Supplement 1

Grand Gulf Nuclear Station

Evacuation Time Estimate

Figure 7-4. Areas of Traffic Congestion
1 Hour after the Advisory to Evacuate (Region R3, Scenario 11)

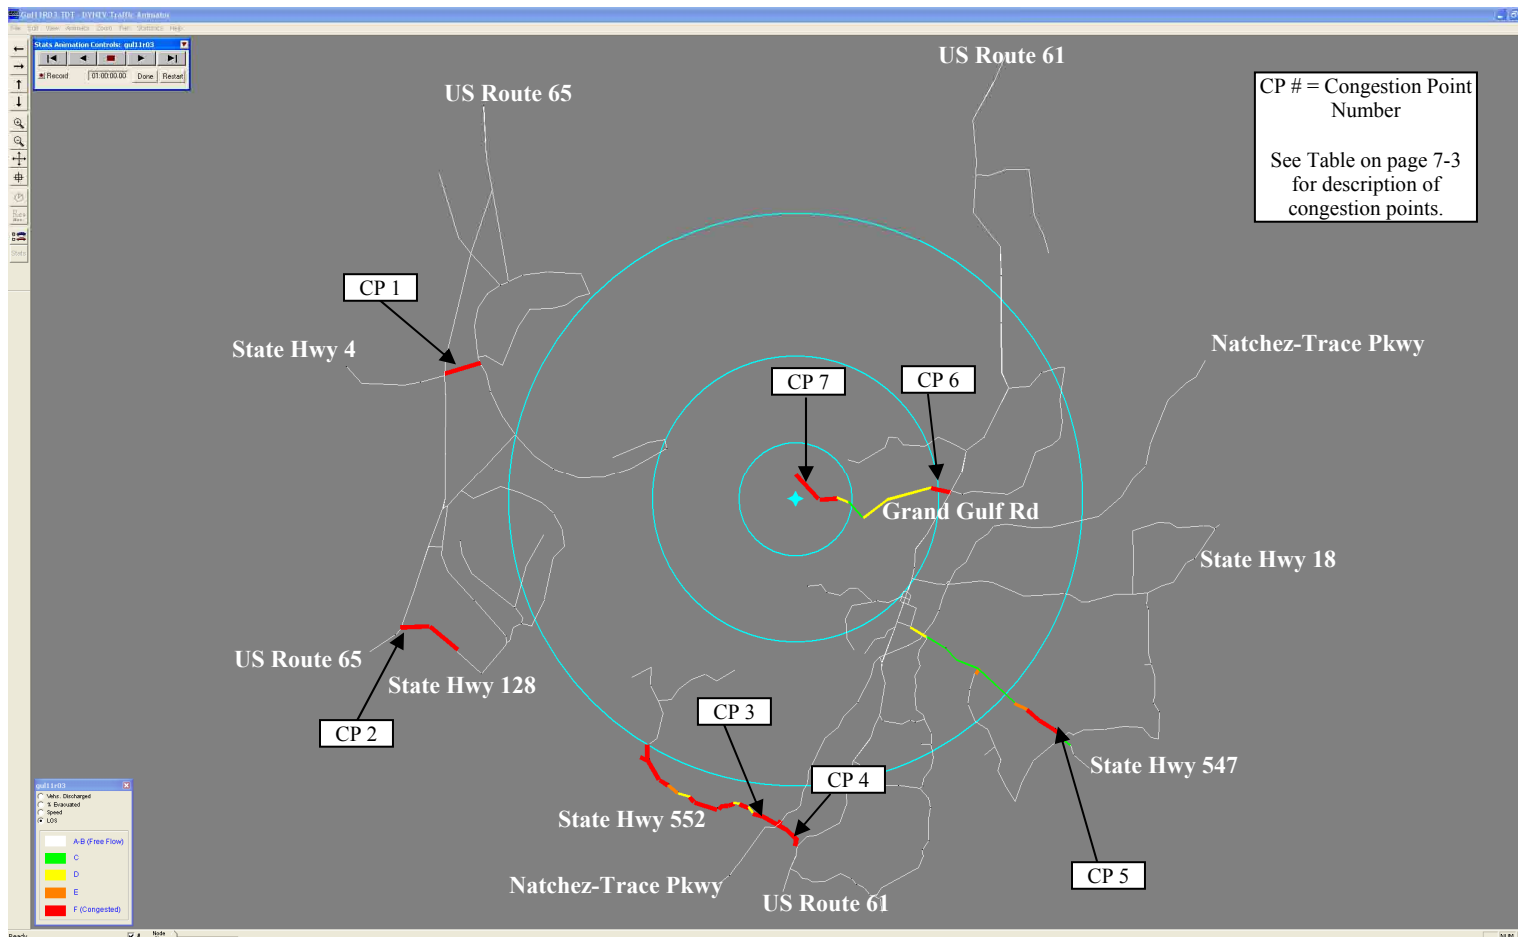
- Label the major evacuation routes and identified congestion points in Figure 7-4. Congestion points reference table “Average Delay for Selected Roadways in the GGNS EPZ,” which is added to page 7-3. See enclosed Figure 7-4 and table “Average Delay for Selected Roadways in the GGNS EPZ.”
- Change the title of Figure 7-4 to “Areas of Traffic Congestion 1 Hour after the Advisory to Evacuate (Region R3, Scenario 11).”

Figure 7-5. Areas of Traffic Congestion
3 Hours after the Advisory to Evacuate (Region R3, Scenario 11)

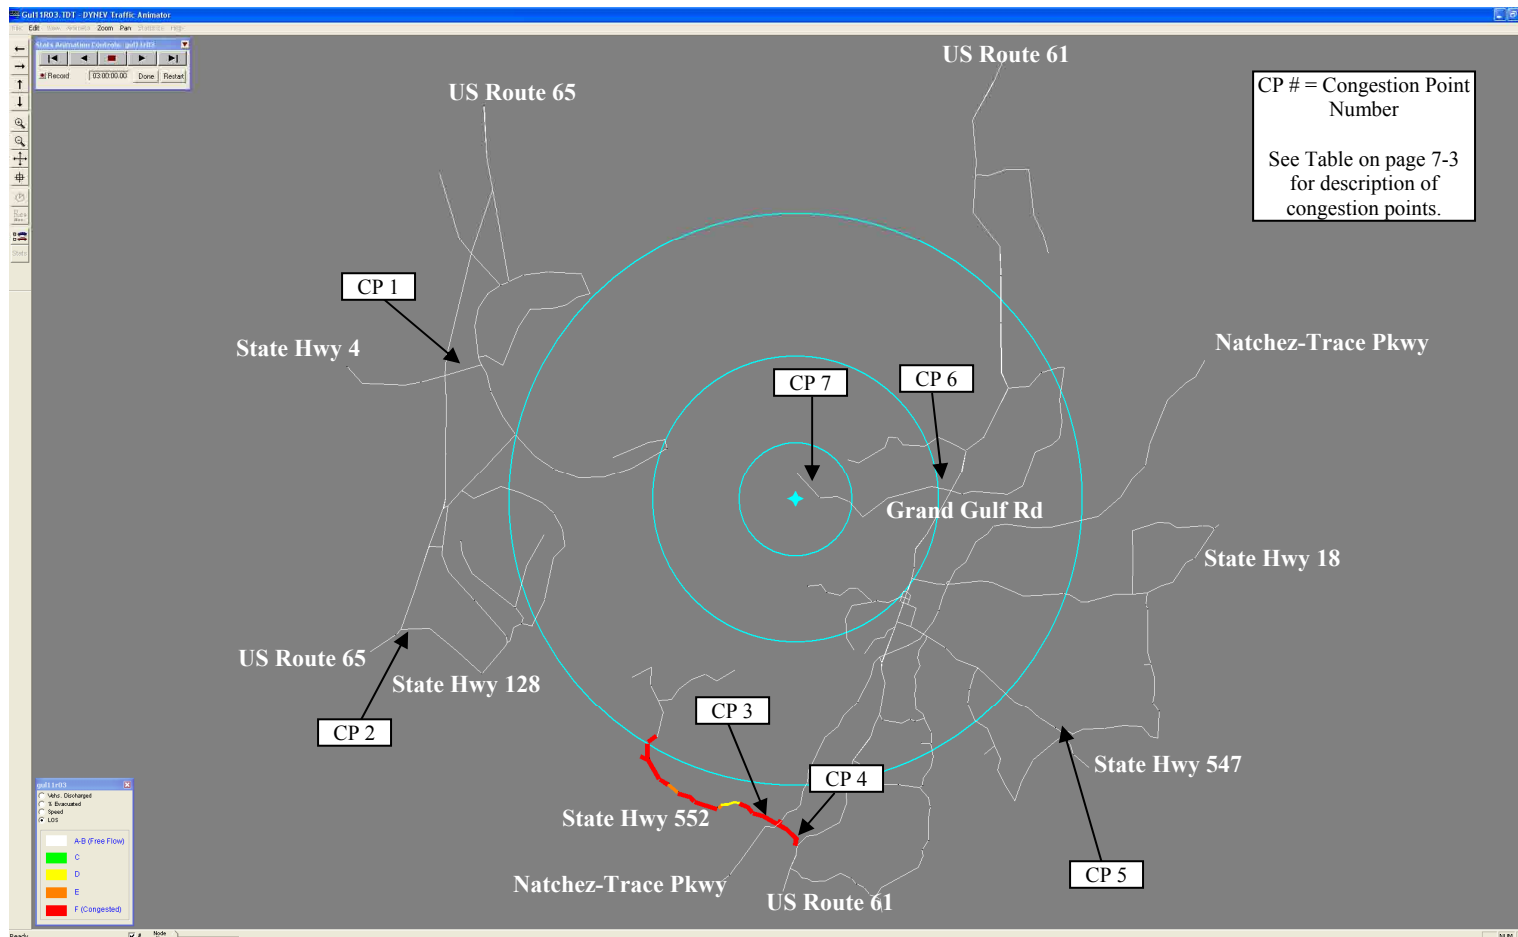
- Labeled the major evacuation routes and identified congestion points in Figure 7-5. Congestion points reference table “Average Delay for Selected Roadways in the GGNS EPZ,” which is added to page 7-3. See enclosed Figure 7-5 and table “Average Delay for Selected Roadways in the GGNS EPZ.”
- Change the title of Figure 7-5 to “Areas of Traffic Congestion 3 Hours after the Advisory to Evacuate (Region R3, Scenario 11).”

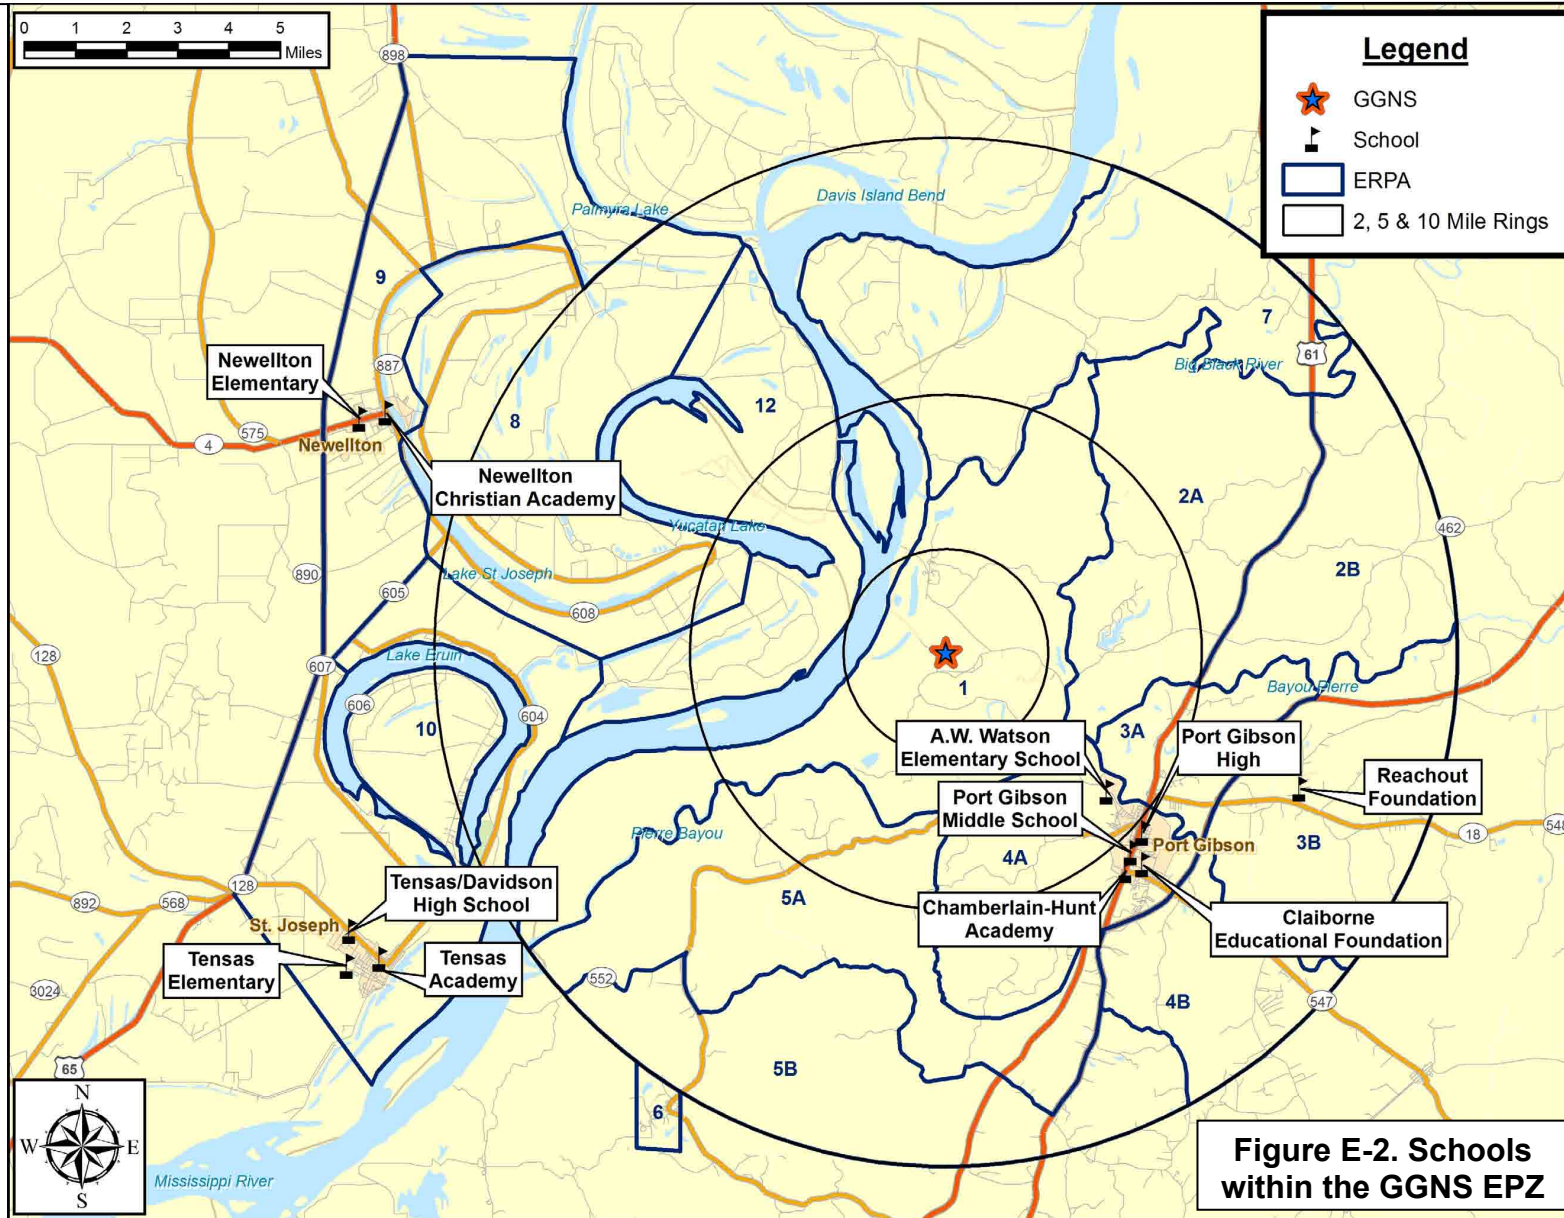
- Add “Figure E-2. Schools within the GGNS EPZ.” See enclosed Figure E-2.

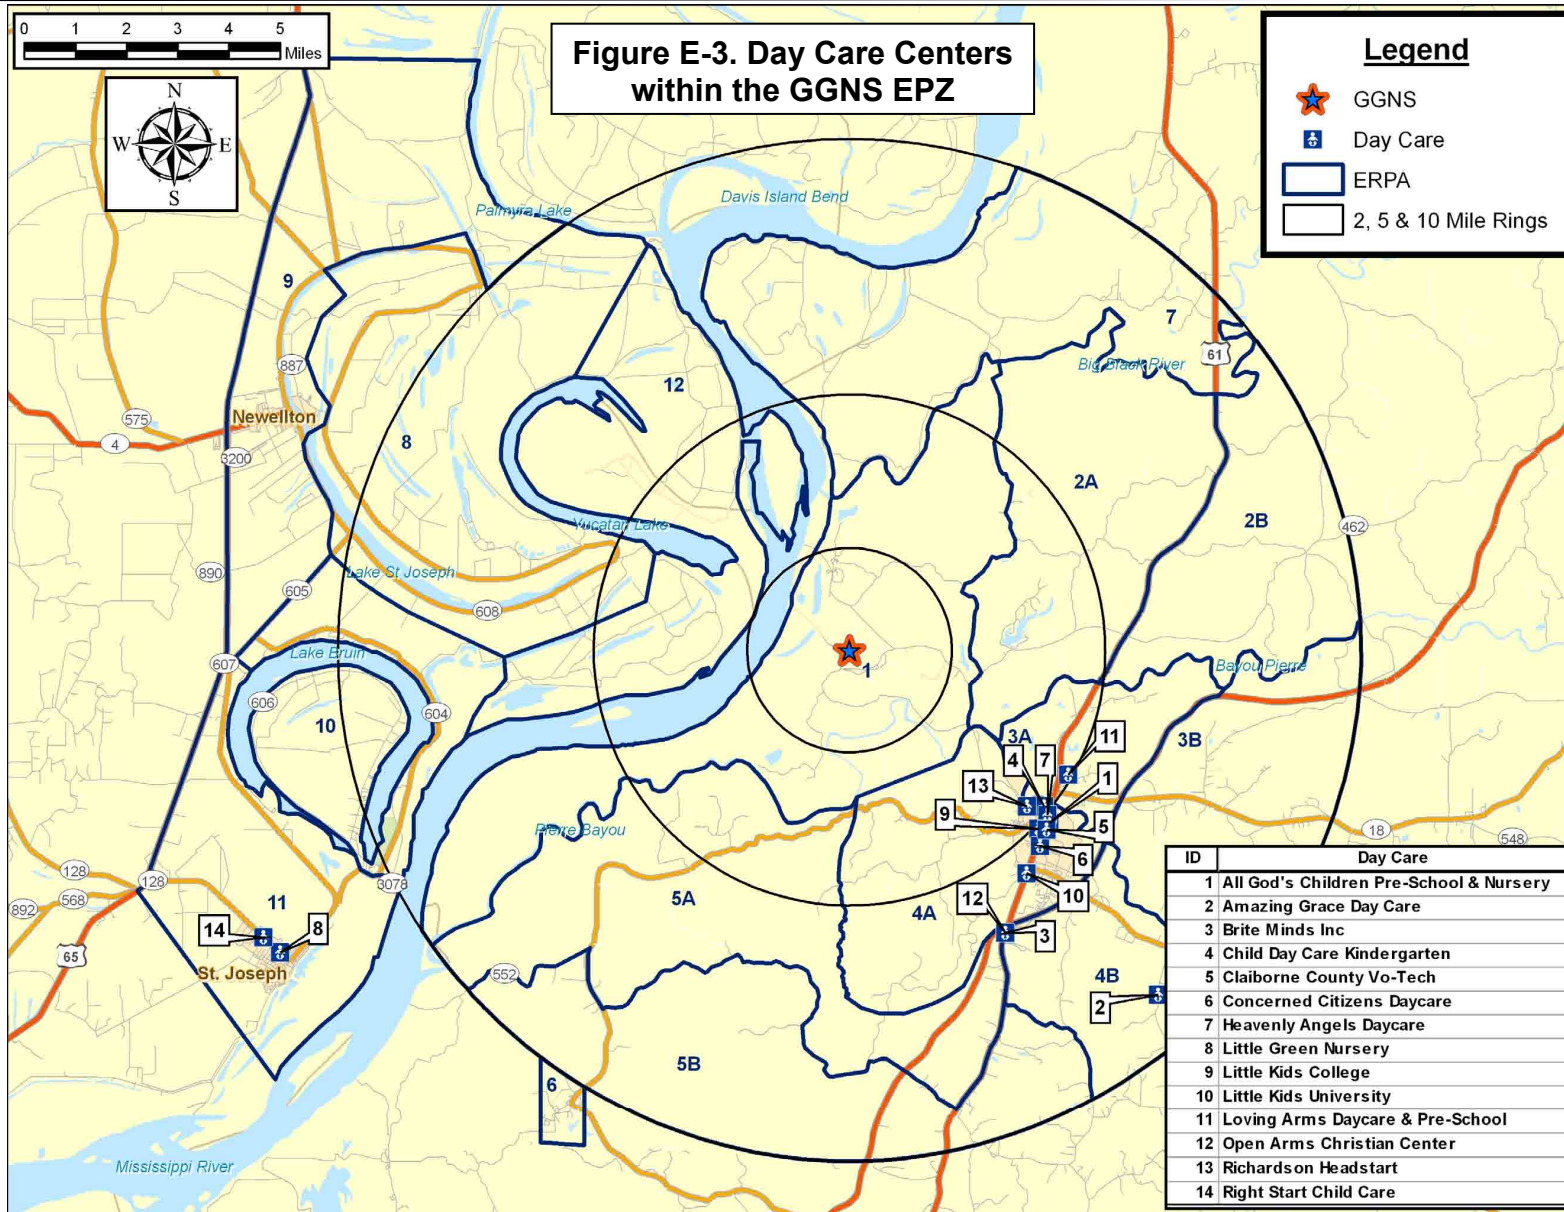
- Add “Figure E-3. Day Care Centers within the GGNS EPZ.” See enclosed Figure E-3.

Figure E-4. Medical Facilities within the GGNS EPZ

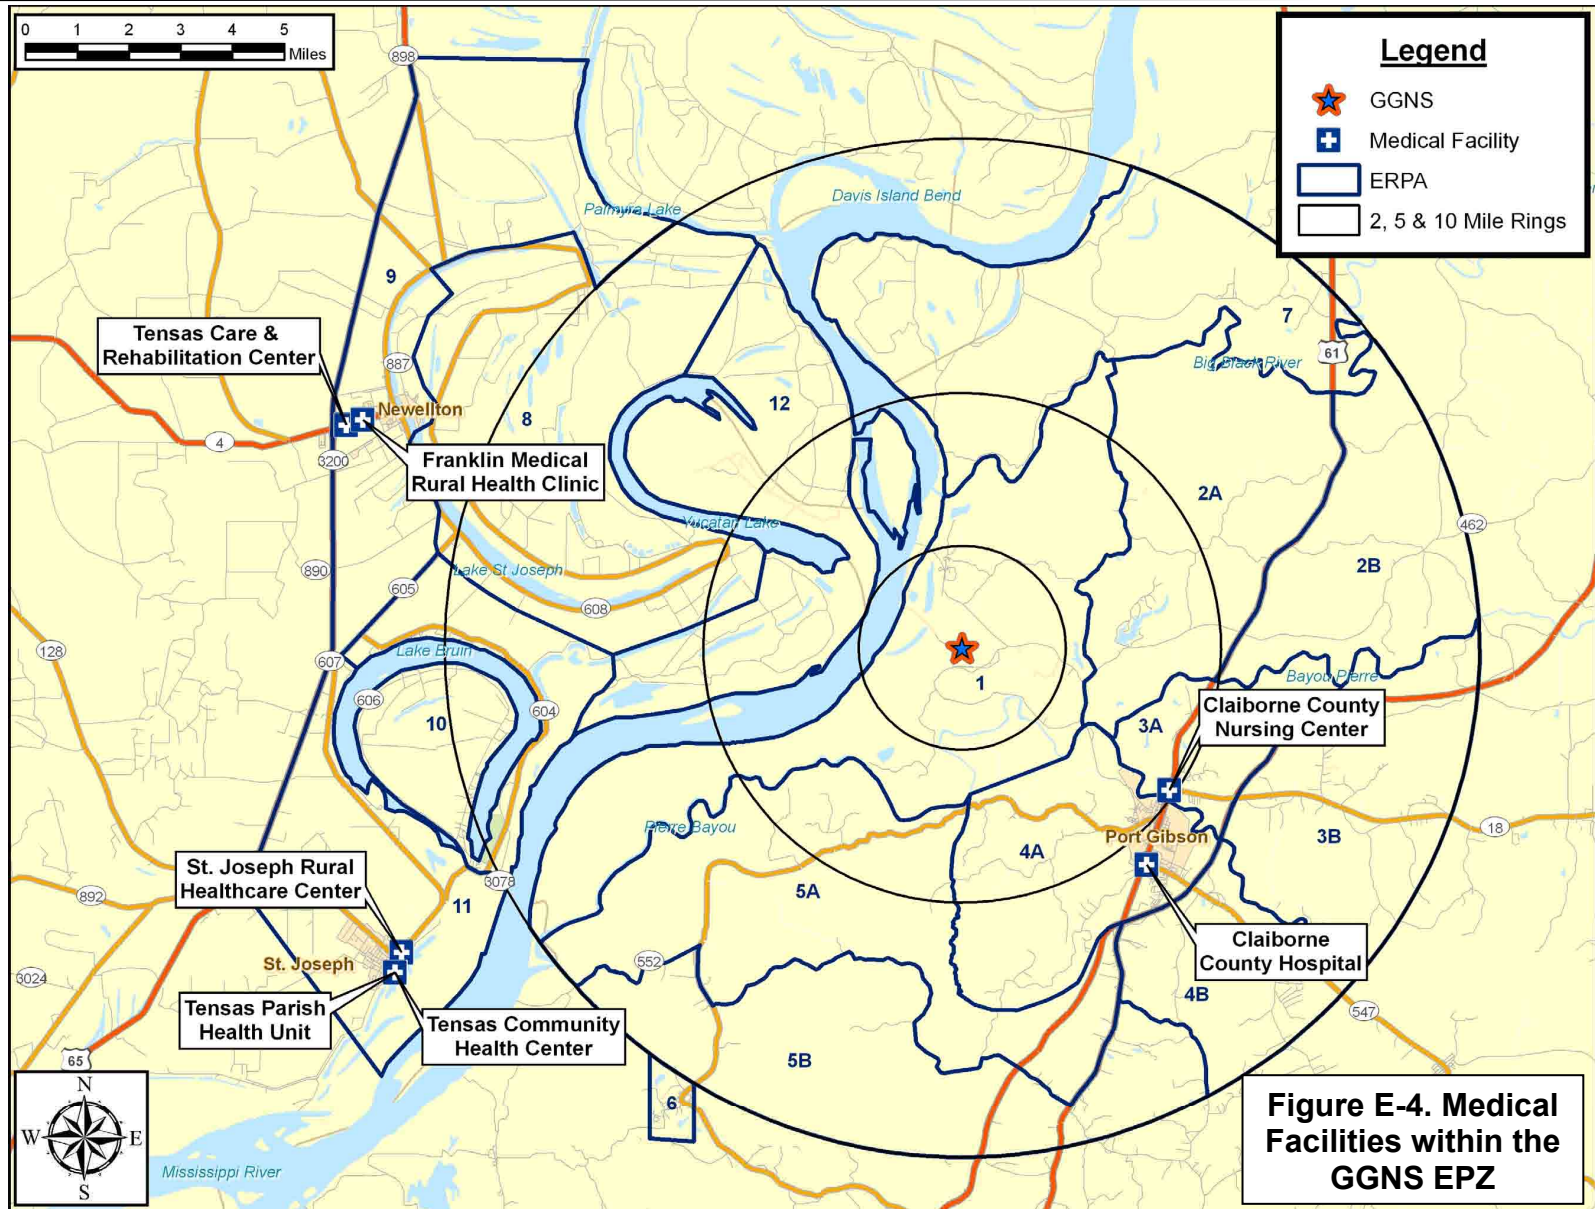
- Add “Figure E-4. Medical Facilities within the GGNS EPZ.” See enclosed Figure E-4.

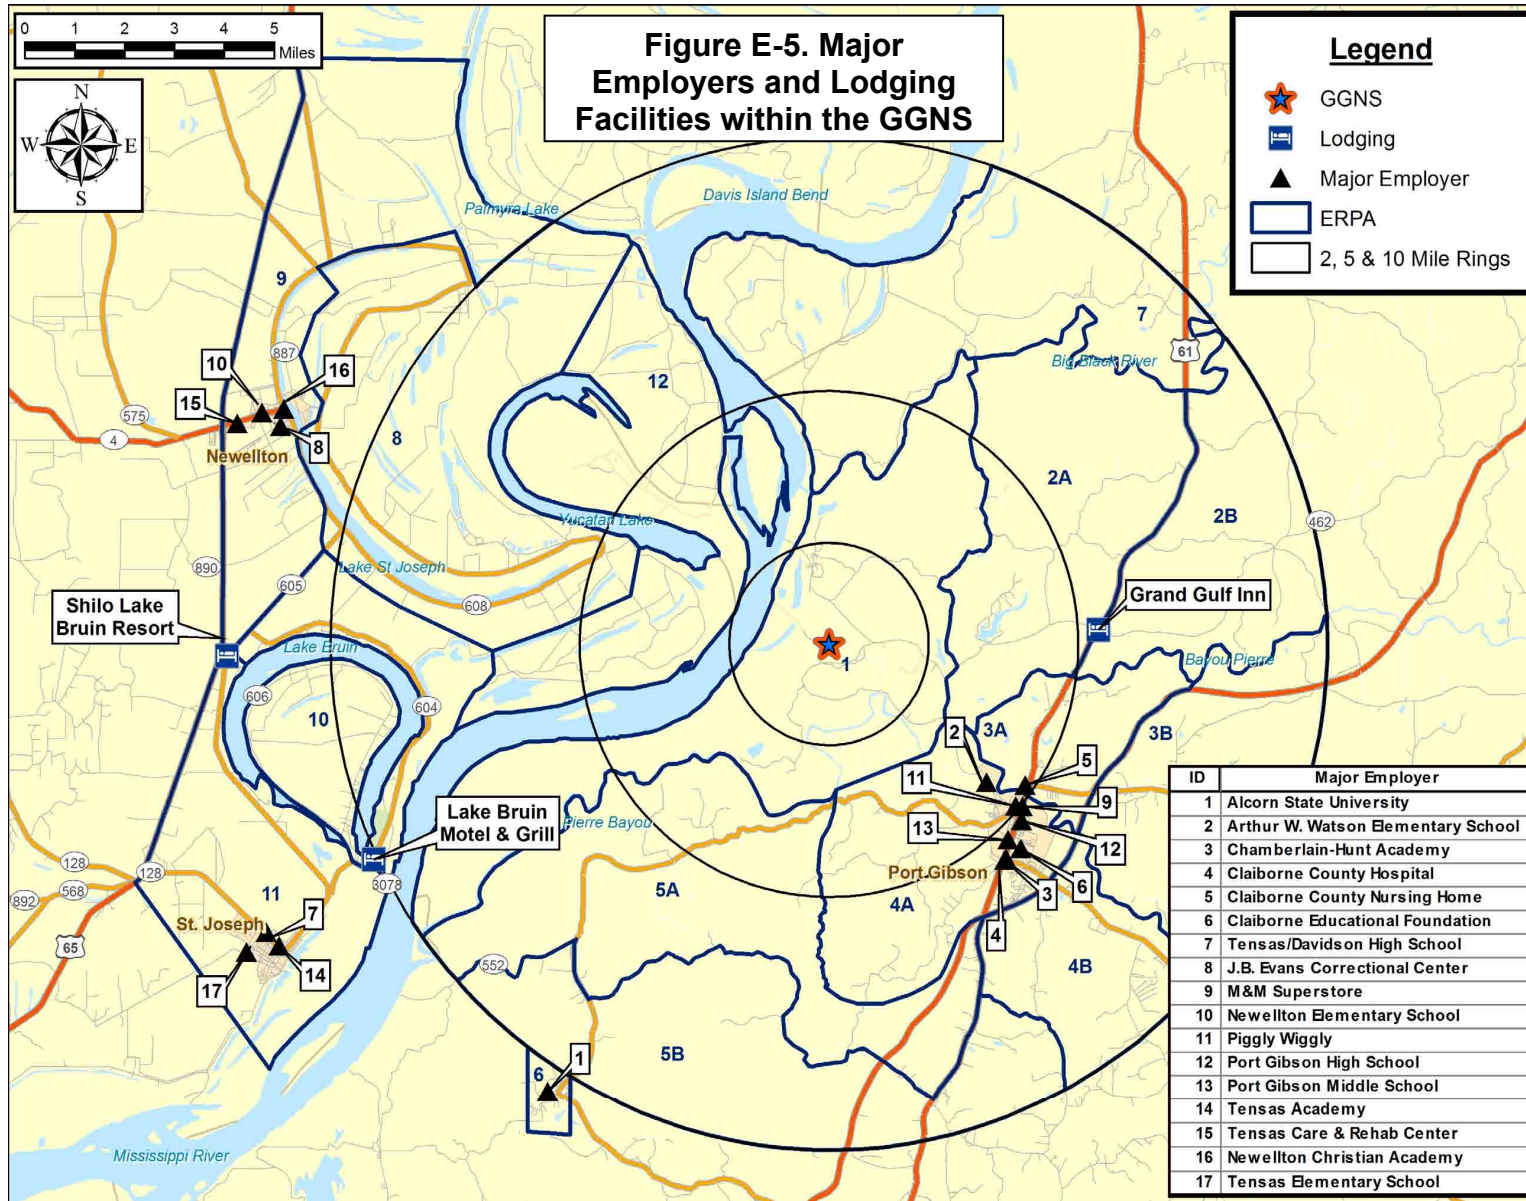
- Add “Figure E-5. Major Employers and Lodging Facilities within the GGNS EPZ.” See enclosed Figure E-5.
